## Reply to Anonymous Referee #1

This manuscript presents an investigation of the spectral misalignment Effect (SMILE) on aerosol and cloud retrievals with a focus over land. A number of potentially important sources of biases are assessed. The paper is well suitable to the scope of AMT, in terms of the question proposed to address.

Figure 1. The relative error of single scattering albedo due to the non-corrected smile effect for different effective radii for ice (reddish colors) and water clouds (bluish colors). The example is given for the SWIR-1 band.

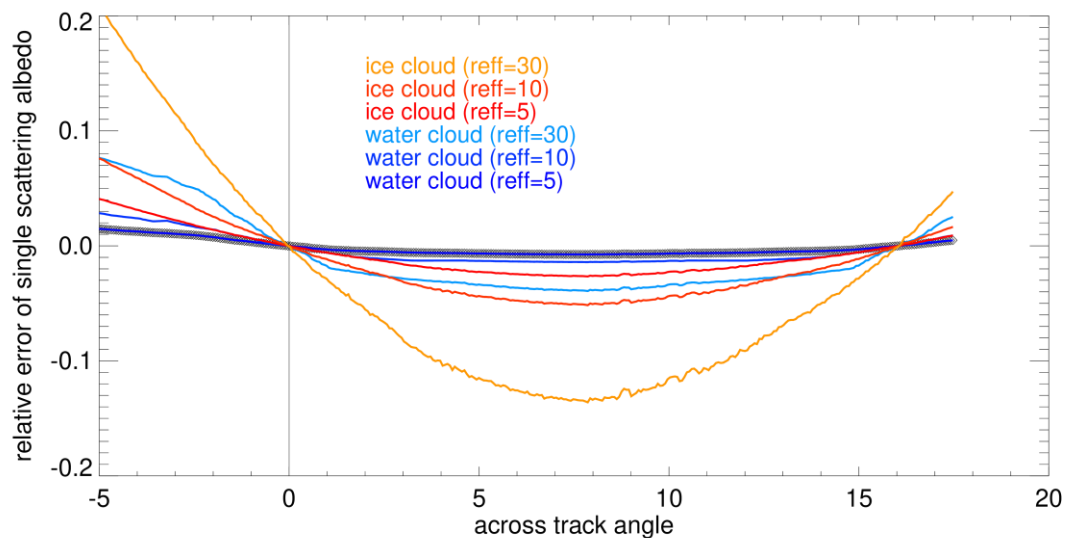
Figure 9: To what extent the results would differ from what you have, if you assumed COT to be 50, or liquid cloud effective radius being 10 or 20 microns?

If we assume cloud with COT=50, the VIS band errors will decrease as the surface will play no important role anymore. To understand the influence due to the cloud effective radius. We added the figure above here. The effective radius values are set to 5  $\mu\text{m}$ , 10  $\mu\text{m}$  and 30  $\mu\text{m}$  with an optical thickness of 10. The surface is not varied. The water and ice absorption channels (SWIR-1) are primarily a function of cloud particle size; this is reflected in the results. The relative error for the single scattering albedo getting stronger for larger cloud particle (**Error! Reference source not found.**).

While an increase in COT with constant effective radius will result in a decreasing relative error, an increase in effective radius assuming a constant COT will result in an increase in relative TOA normalized radiance error in only the SWIR1 band.

**Figure 2 International Satellite Cloud Climatology Project (ISCCP) cloud type definition in dependence on cloud optical thickness and cloud top pressure. Figure taken from: <https://isccp.giss.nasa.gov/cloudtypes.html> (last access: 09 February 2024)**

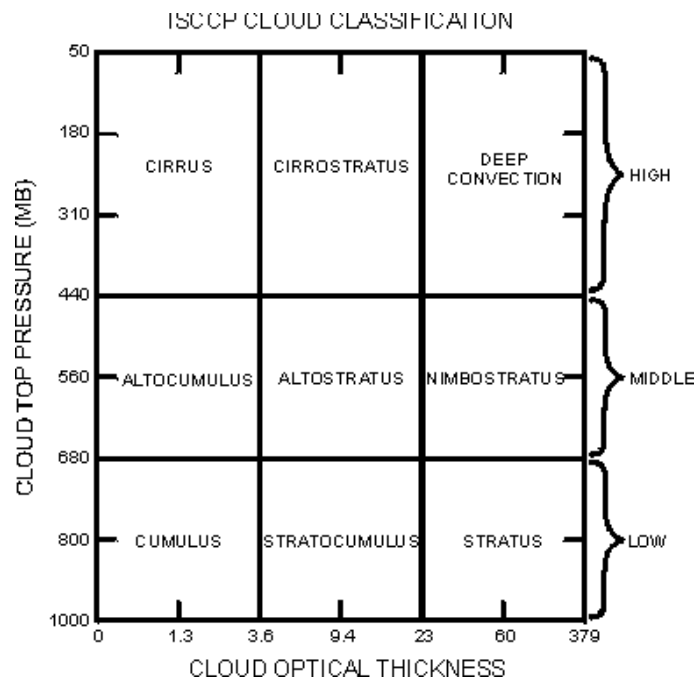
Line 205: optical thickness of 10 is low for stratocumulus. Please justify your choice.

Our target was to understand the possible error sources caused by the SMILE. One gets a good first approximation using a COT of 10. The value has been chosen for convenience

and is representative according to ISCCP (online: <https://isccp.giss.nasa.gov/cloudtypes.html> (last access: 09 February 2024)).
